**VILLAGE OF DOWNERS GROVE
REPORT FOR THE VILLAGE COUNCIL MEETING
MAY 15, 2012 AGENDA**

SUBJECT:	TYPE:	SUBMITTED BY:
Annexation with Rezoning to B-2, Lot Consolidation and Special Use for a drive-through use	<ul style="list-style-type: none"> ✓ Resolution ✓ Ordinance Motion Discussion Only 	Tom Dabareiner, AICP Community Development Director

A resolution and ordinances have been prepared for annexation, rezoning, lot consolidation and special use for a Walgreens store at the northwest corner of 63rd Street and Woodward Avenue.

To: Plan Commission
From: Jeff O'Brien, AICP, Planning Manager
Subject: PC-39-11, Annexation with Rezoning to B-2, General Retail Business, Final Plat of Subdivision for Lot Consolidation and Special Use for a drive-through use – Northwest corner of 63rd Street and Woodward Avenue
Date: January 9, 2012

DRAWING NO. **C-100**

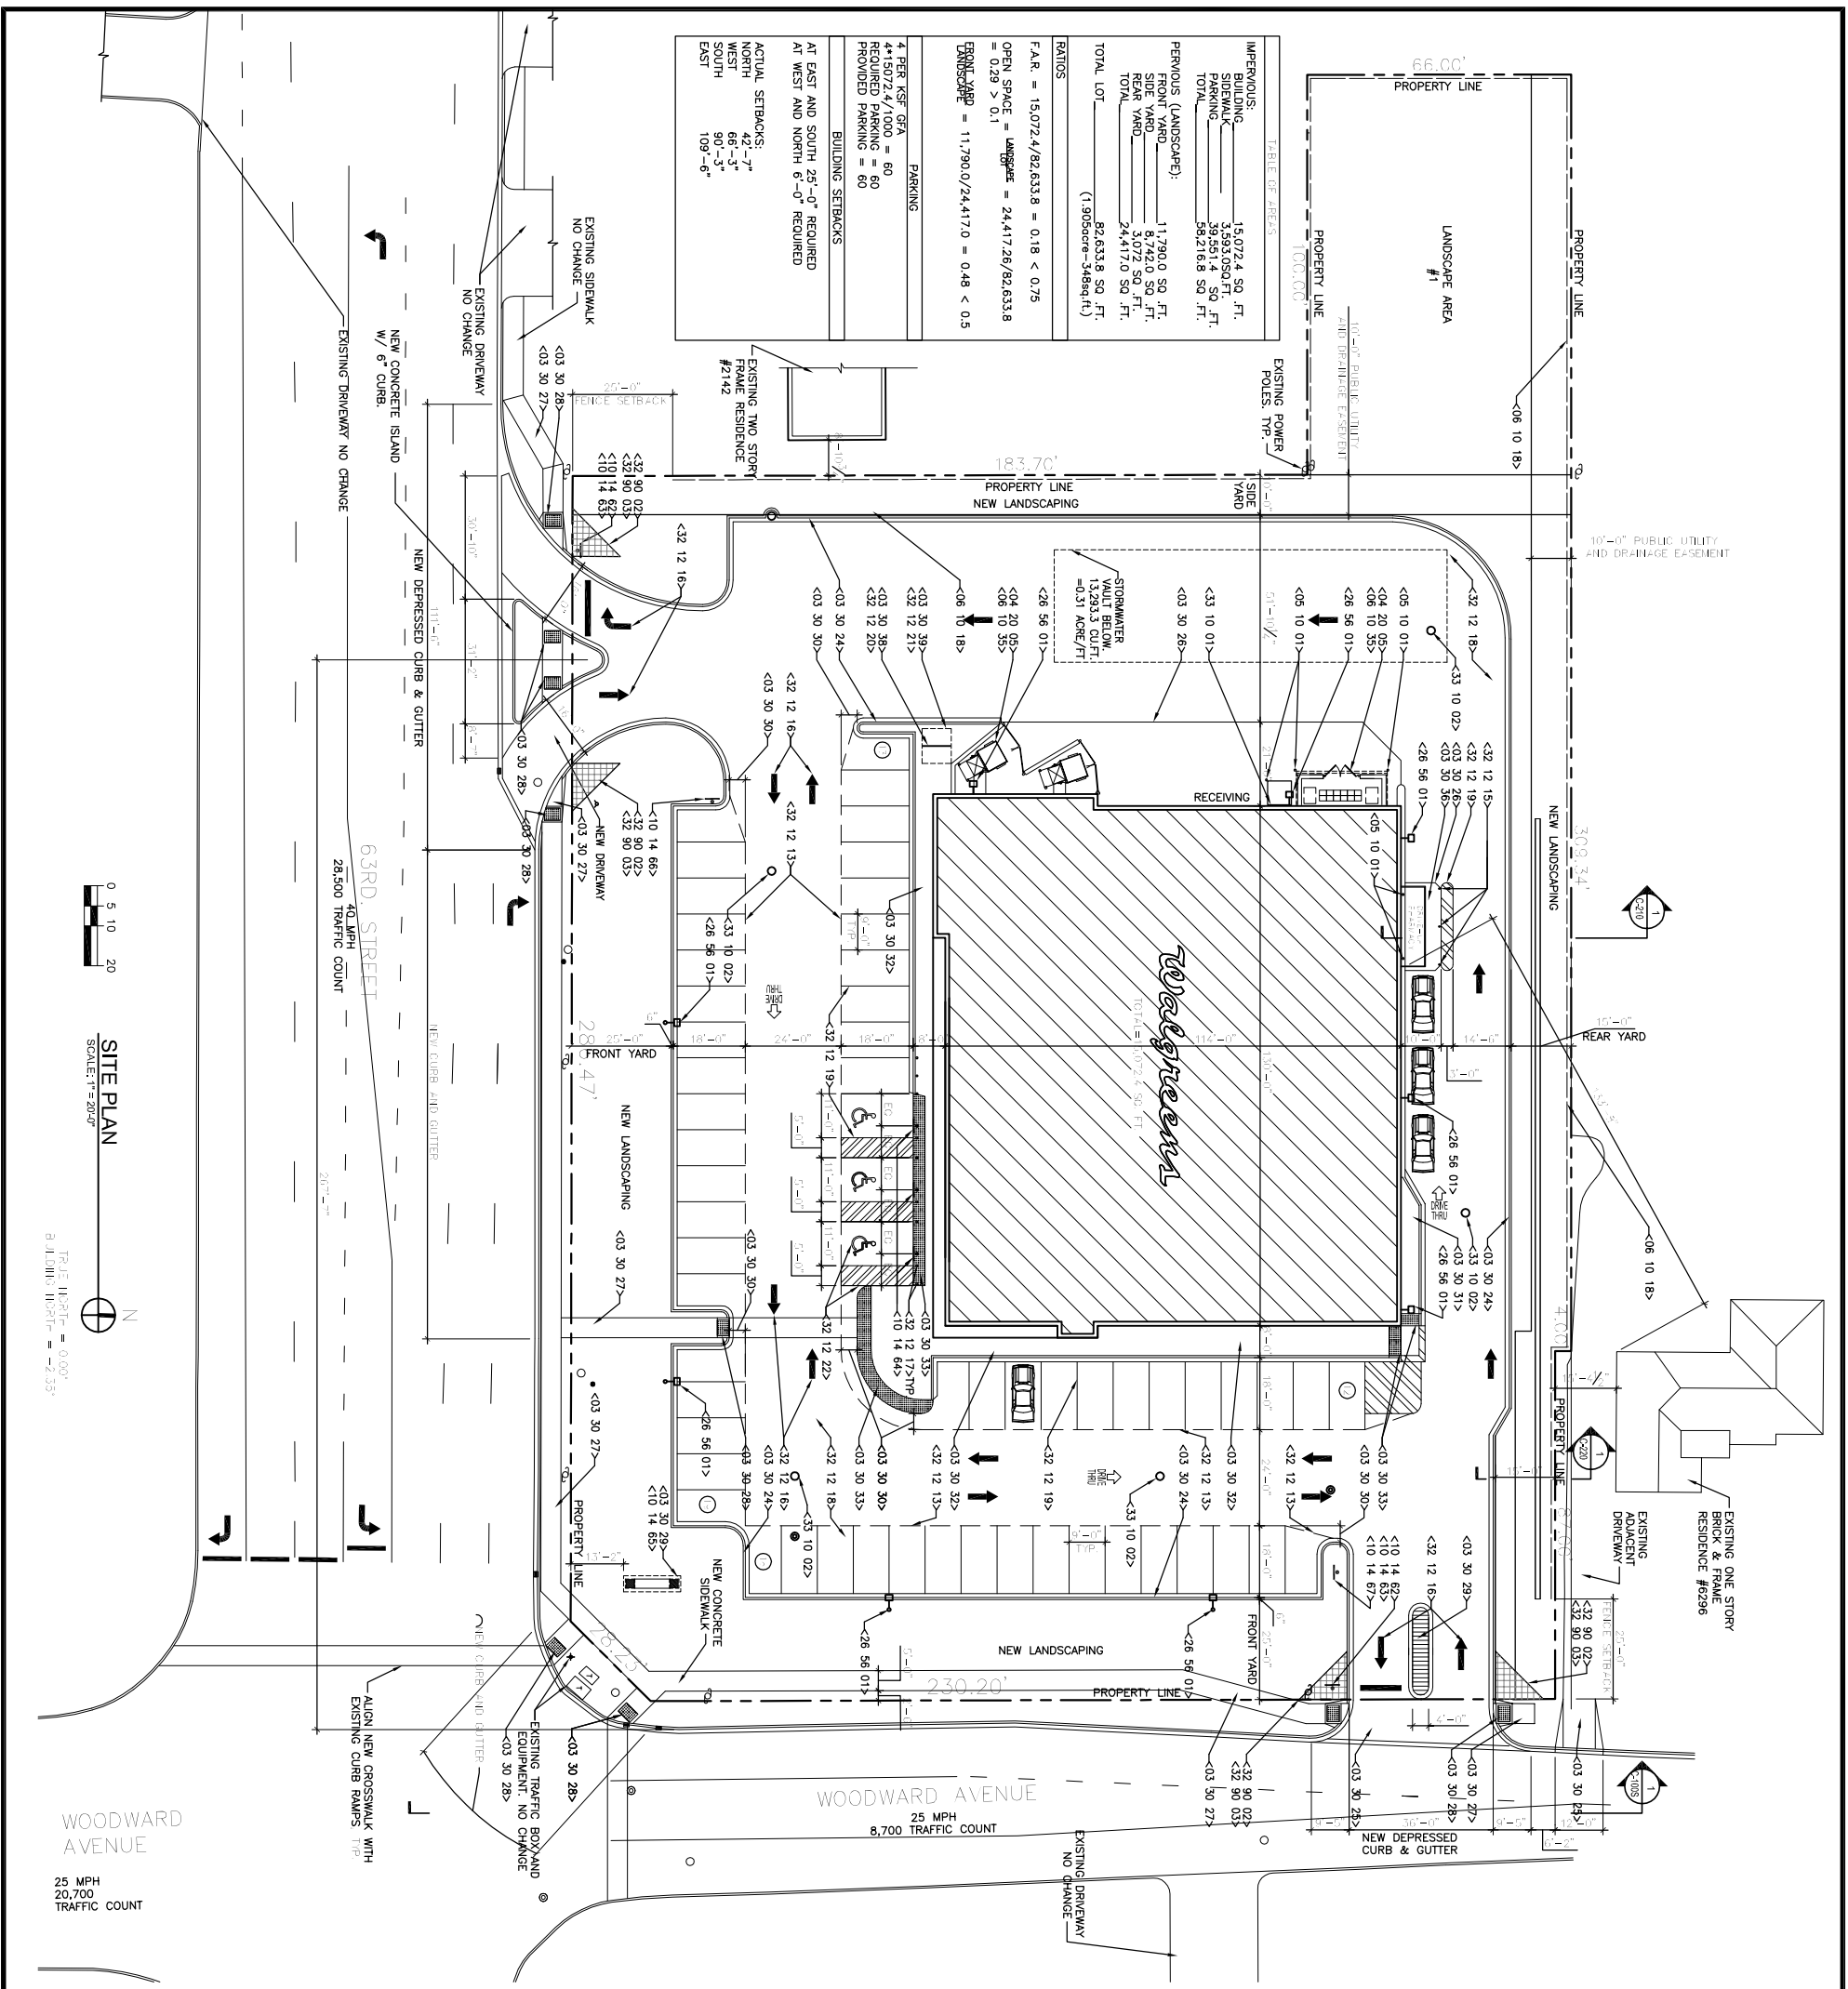
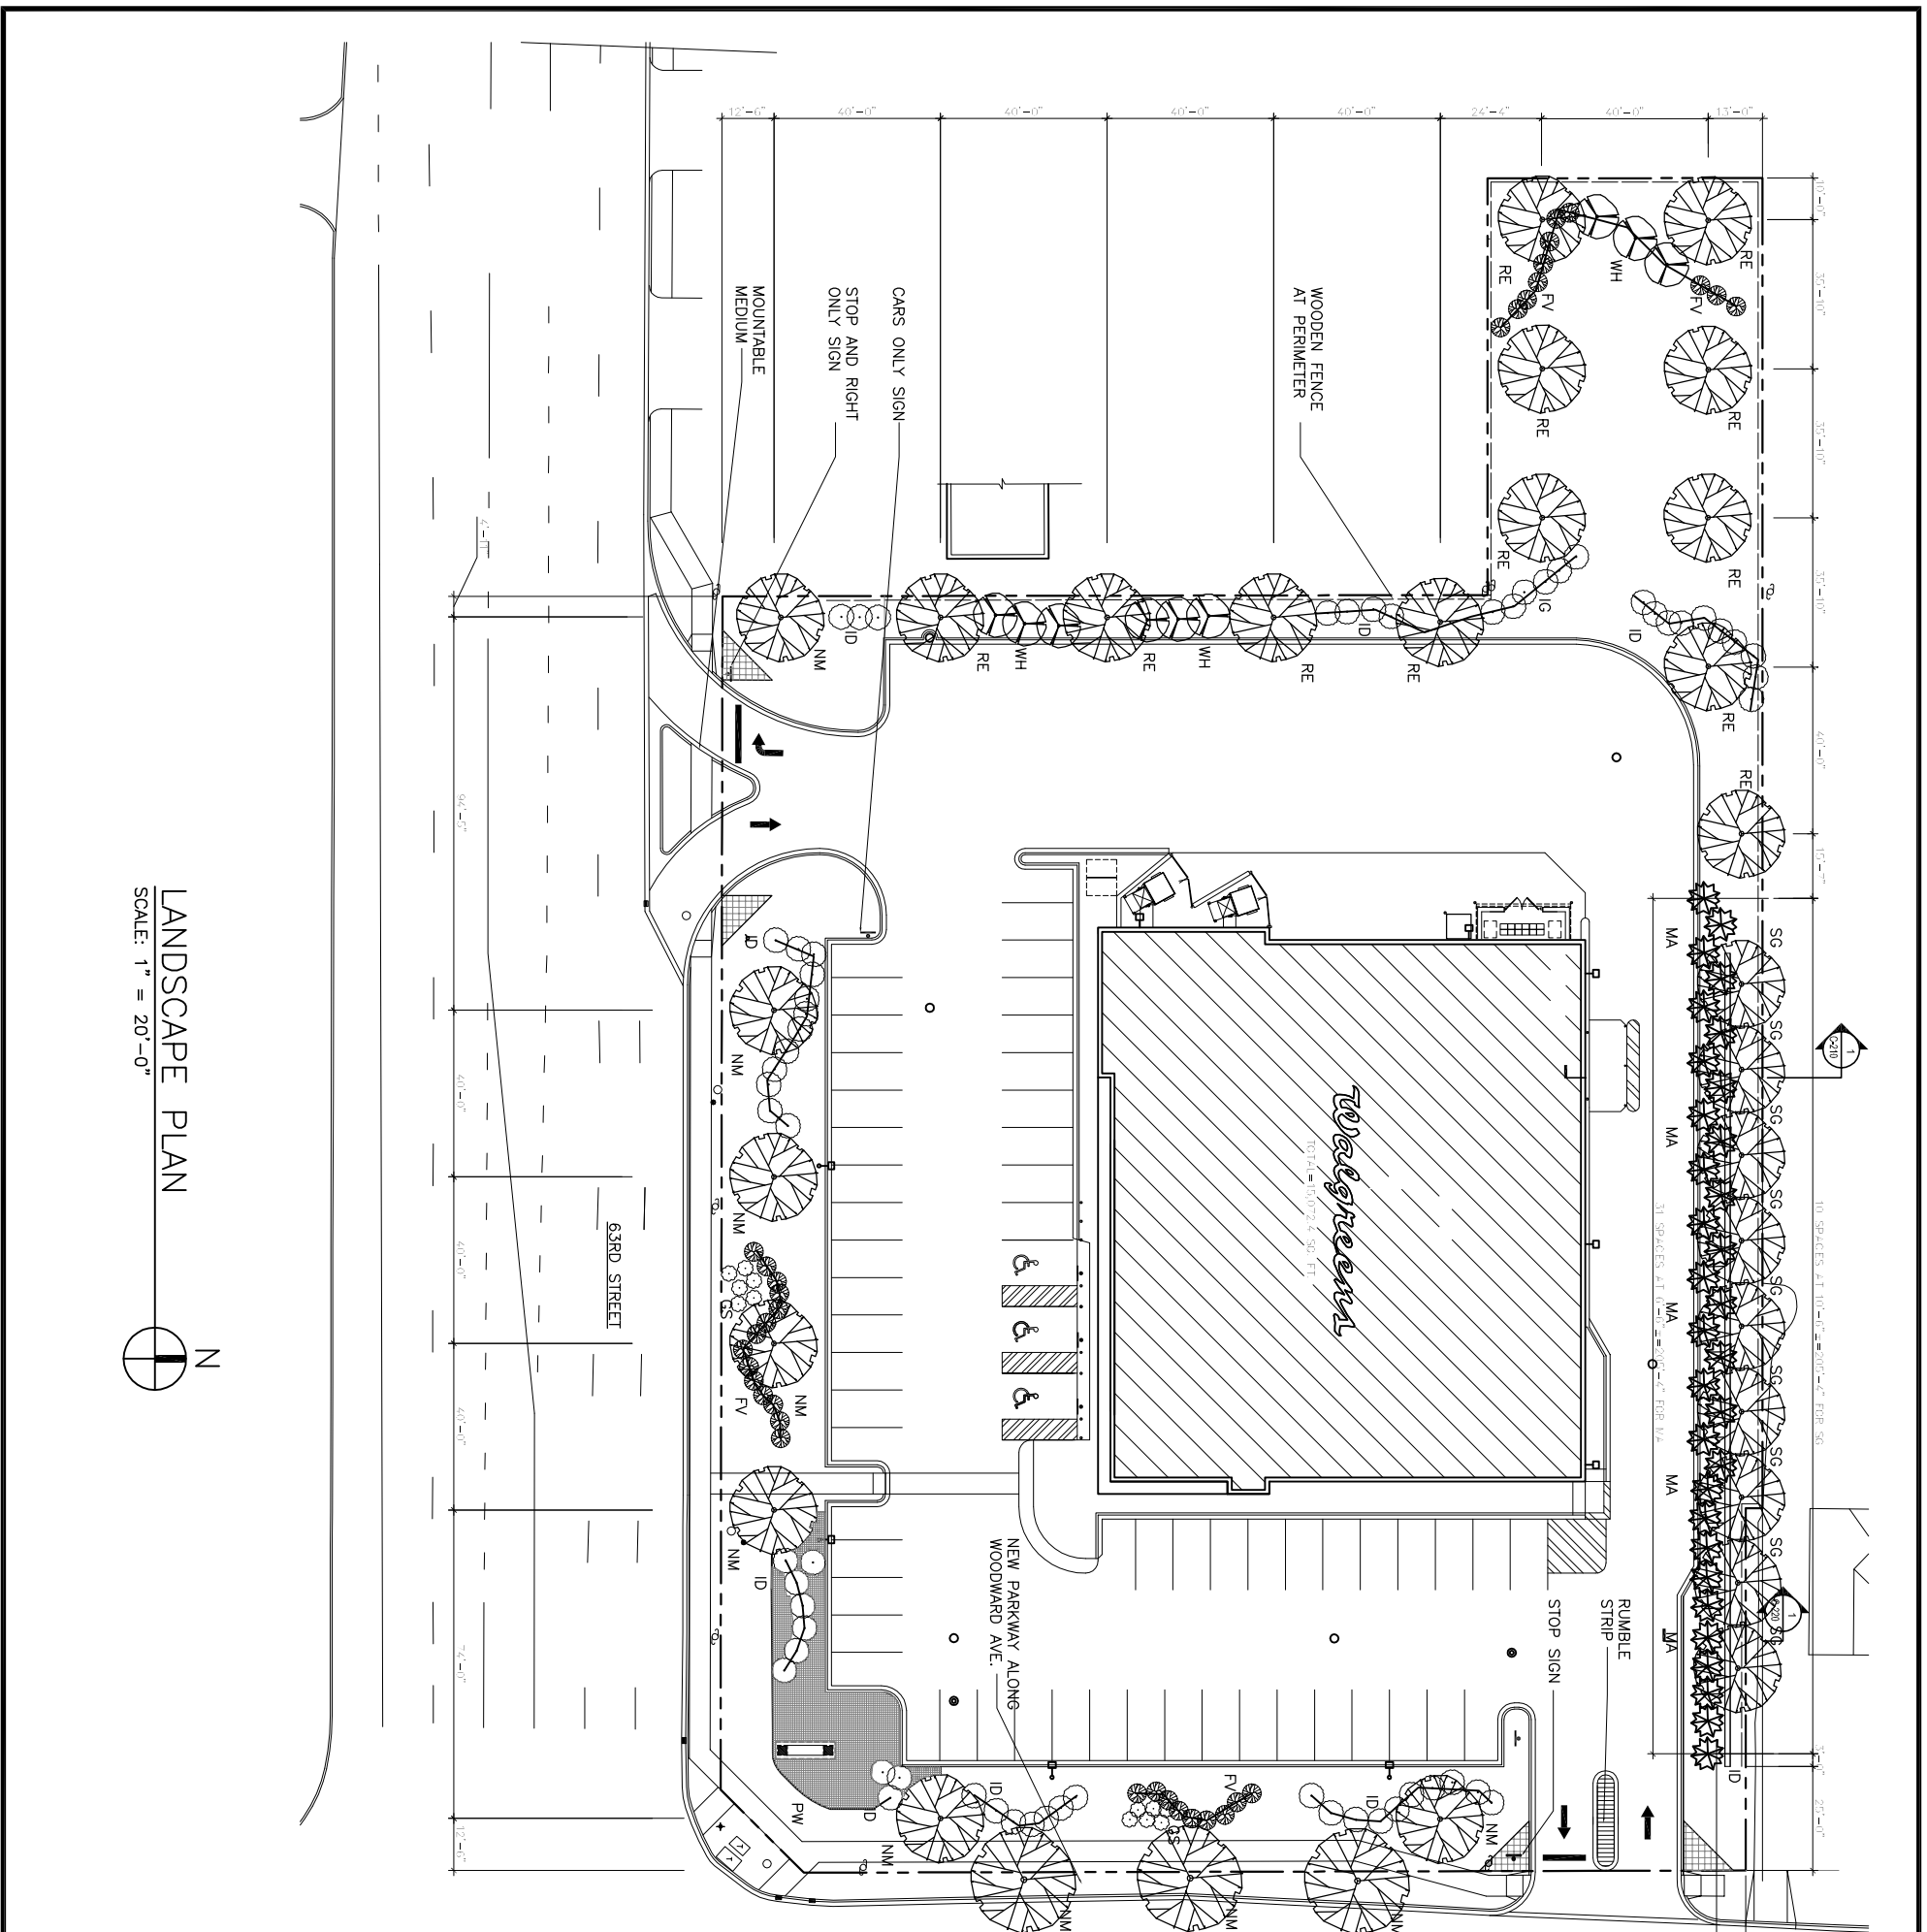
This item was discussed at the February 7, 2012 Village Council meeting. The petitioner has submitted revised plans that show right-in, right-out only on 63rd Street and one lane in, one lane out on Woodward, with a sign prohibiting left turns from the site onto Woodward. The conditions of the attached special use ordinance have been changed to reflect this design. Staff recommends approval on the June 5, 2012 Active Agenda. The revised site plans are attached.
